CITY OF SEASIDE
BOARD OF ARCHITECTURAL REVIEW

REGULAR MEETING
COUNCIL CHAMBER
440 Harcourt Avenue
Wednesday, July 6, 2016
5:30 PM

- B. **Architectural Review Application No. BAR-16-02: Martin Morales, Property Owner, and Sergio A. Vaca, Applicant, request design review approval to demolish an existing one-story residence and construct a new 1,776 square foot, two-story single-family dwelling, and a new one-story 441 square foot two-car detached garage located at 1098 Clementina Avenue in the RH, High Density Residential Zoning District.**

On June 1, 2016, the BAR provided the following recommendations for plan revisions. The responses to BAR comments are shown below.

DETAIL SC: 1"=1'-0" 1

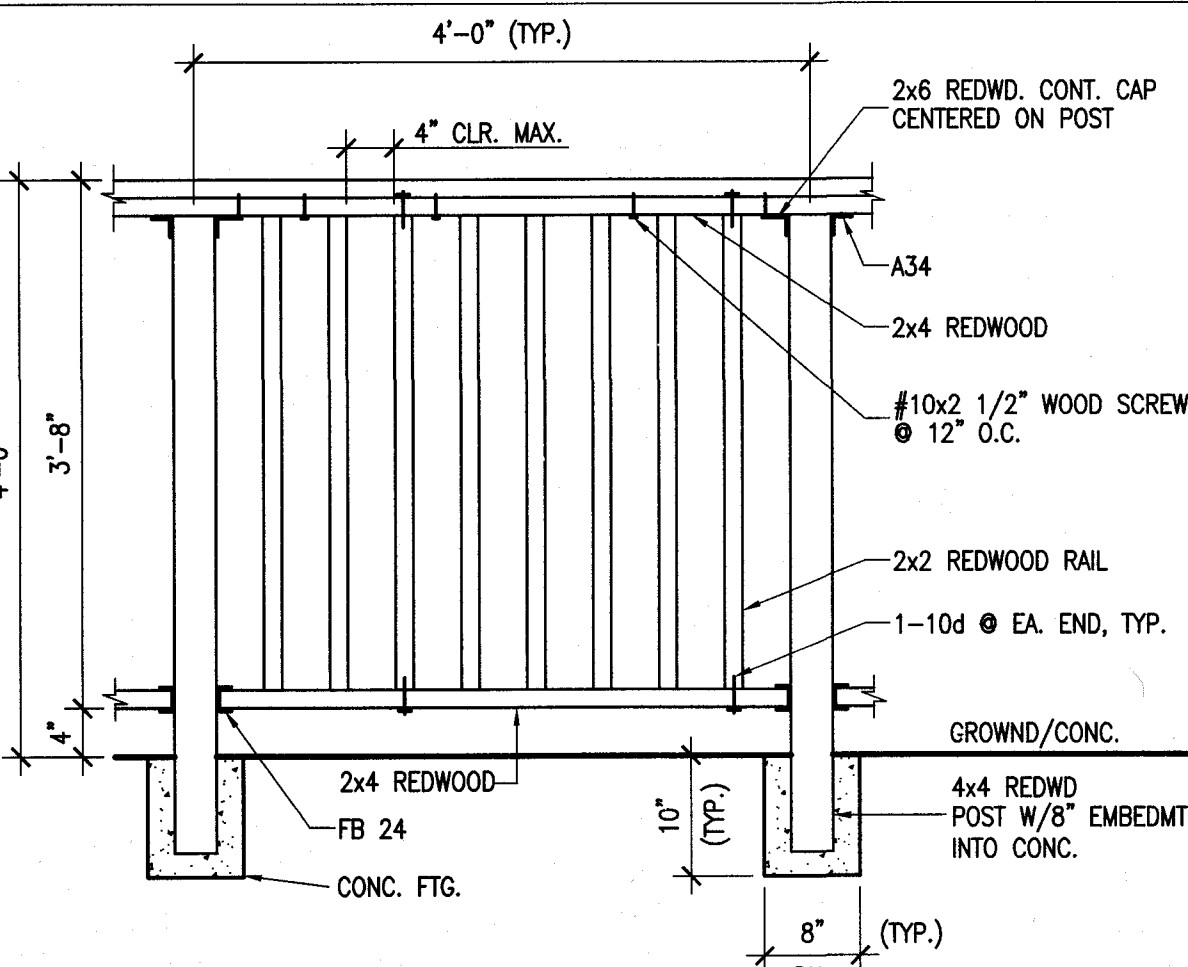
2. Provide proposed 4' fence design and location on site.

Response: Revised Plans, sheet A1, Detail 1, shows proposed four foot high redwood open rail fence with 2" x 2" redwood vertical rails placed approximately 4" on center. The site plan, also on sheet A1, indicates that the four foot high fence is to be located around the perimeter of the site and along the driveway. The existing six foot high fence along the shared property line to the west remains in place. No new six foot fence is proposed. As proposed, the new four foot high redwood fence is consistent with the traffic safety visibility areas at a corner lot and adjacent to the driveway as specified in Municipal Code Section 17.30.030.E.2. The open rail fence is consistent with the Seaside Single-Family Residential Design Guidelines, which encourages fence visibility for safety purposes particularly on corner lots.

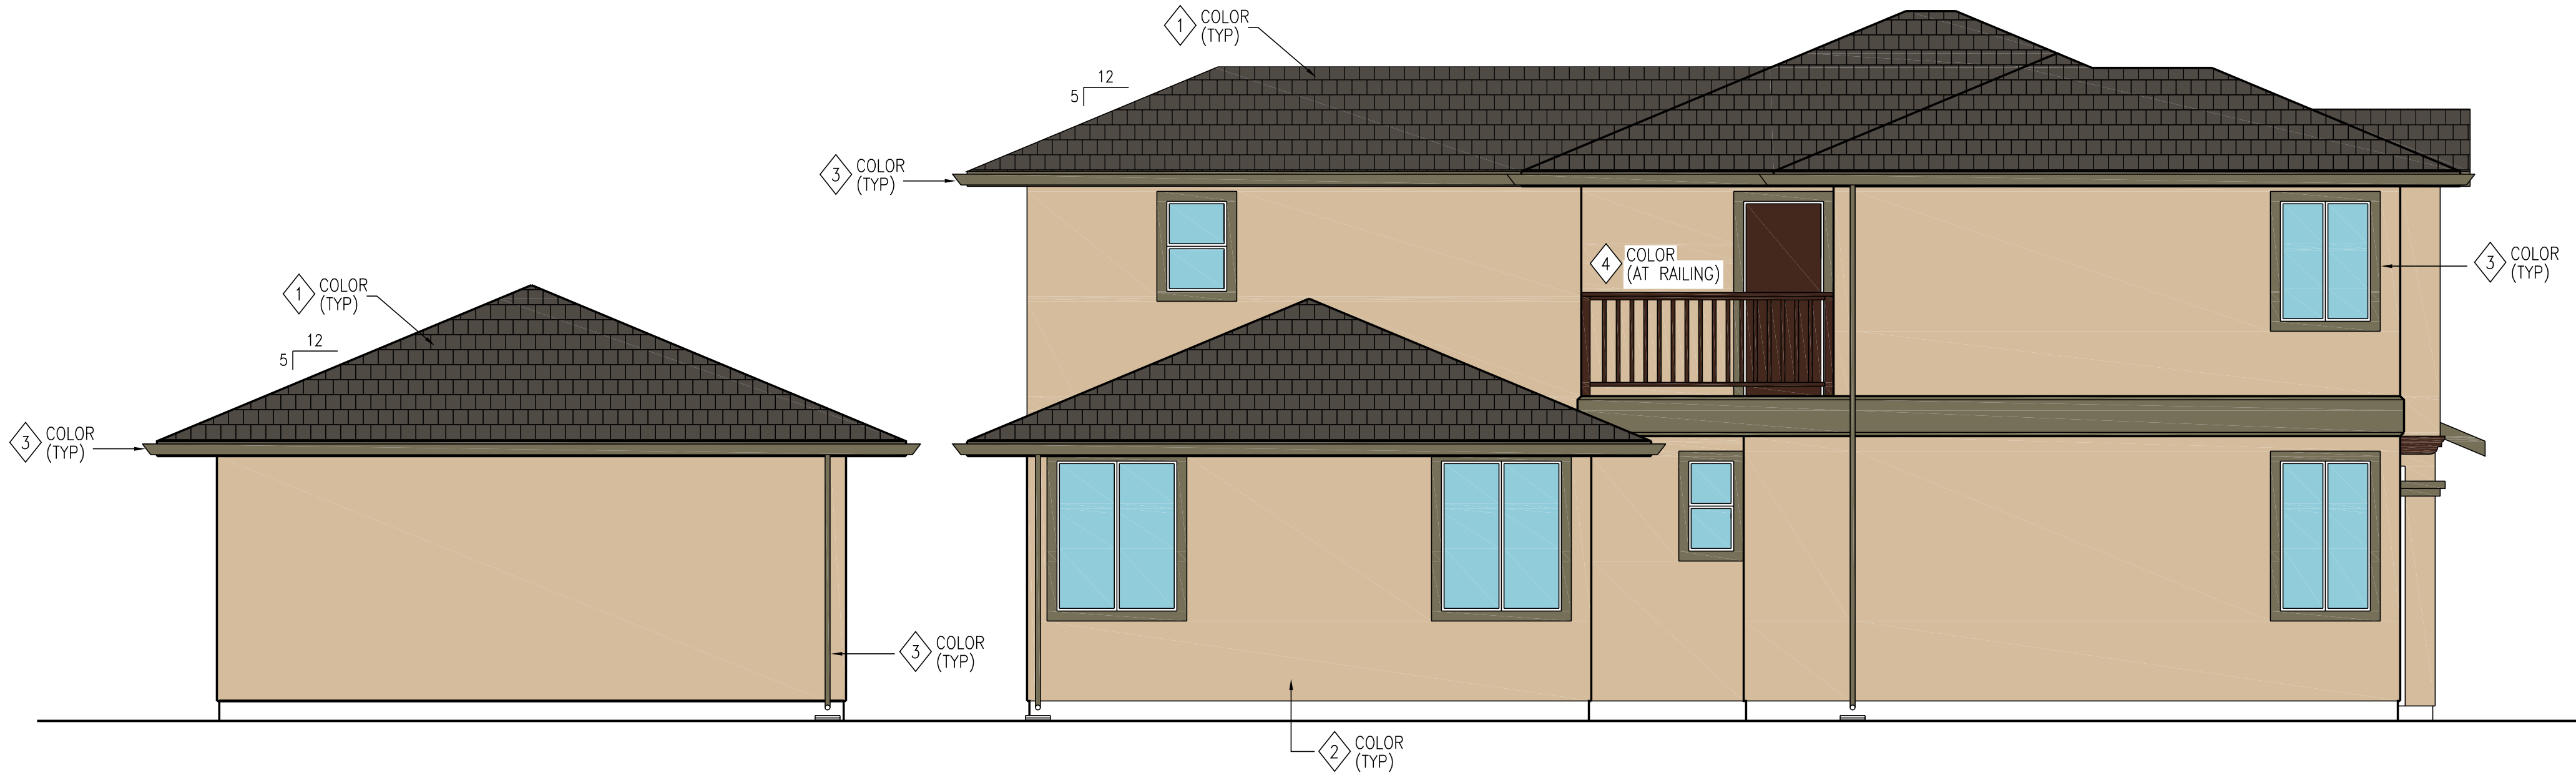
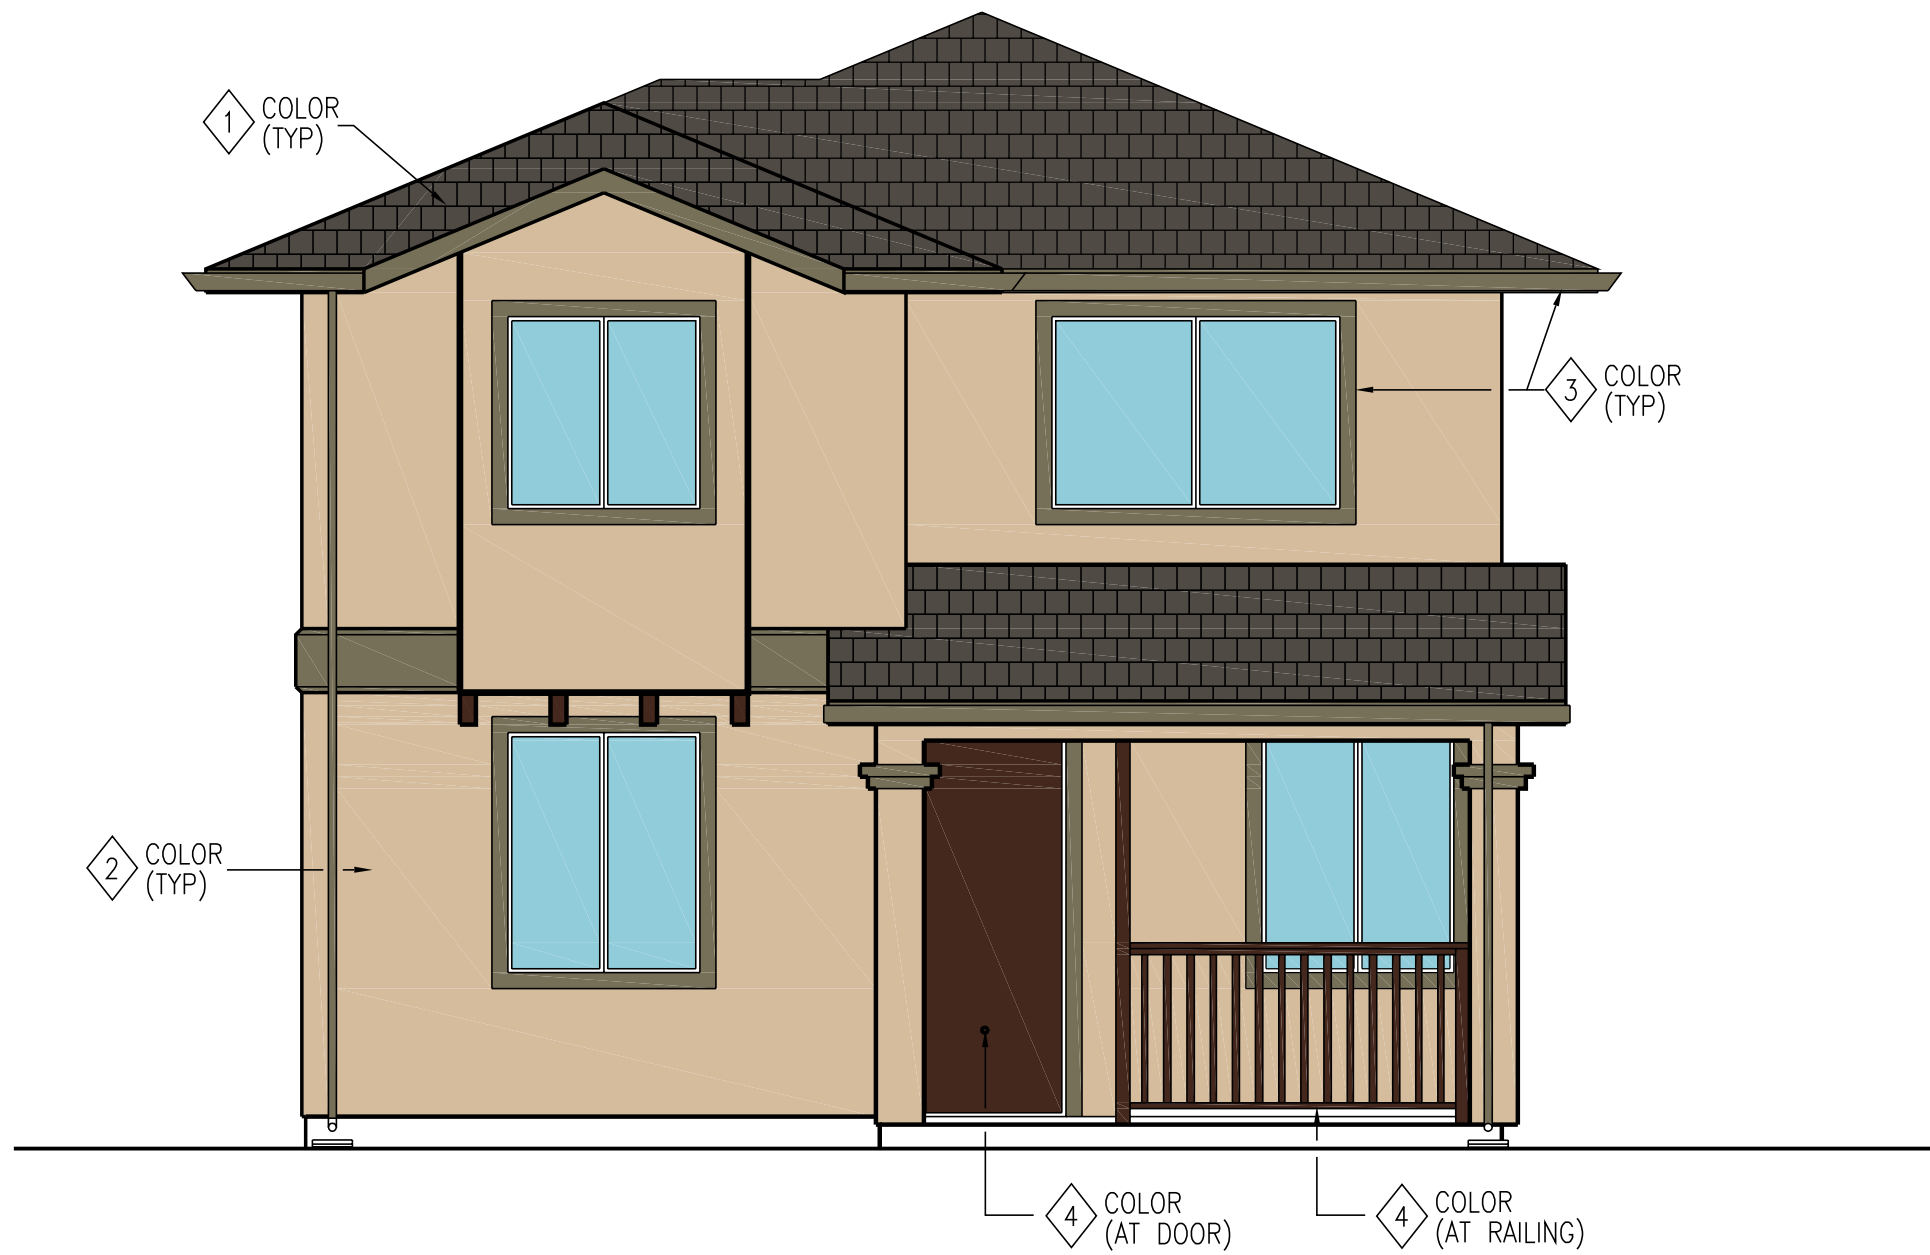
11. Consider cutting back the roof extension on rear elevation (Sheet A3, Back Elevation)

Response: Revised plans, Sheet A3, Right (West) elevation, shows the center stairwell window reduced in size from 4060 to 5030. The applicant has stated that stairwell lighting would be designed to illuminate each stair landing and would not be centered on the window. The applicant has further stated that the window would have obscure glass which would enhance privacy and help diffuse any interior lighting. Staff supports these measures. Conditions of approval require that interior stairwell lighting be placed away from the window to avoid glare onto the neighboring property and that obscure glass be used in that window.

Response: The right (West) elevation, Sheet A3, has been revised to show a solid balcony rail facing the neighboring property to the west.

Response: Revised elevations, Sheet A3, show a belly band incorporated around each elevation of the proposed home. The belly band is shown to be painted the trim color, San Antonio Sage, to match and tie in with the window and door trim, and roof fascia.

Response: The applicant has revised their plan, Sheet A3, cutting back the roof overhang along the back elevation.
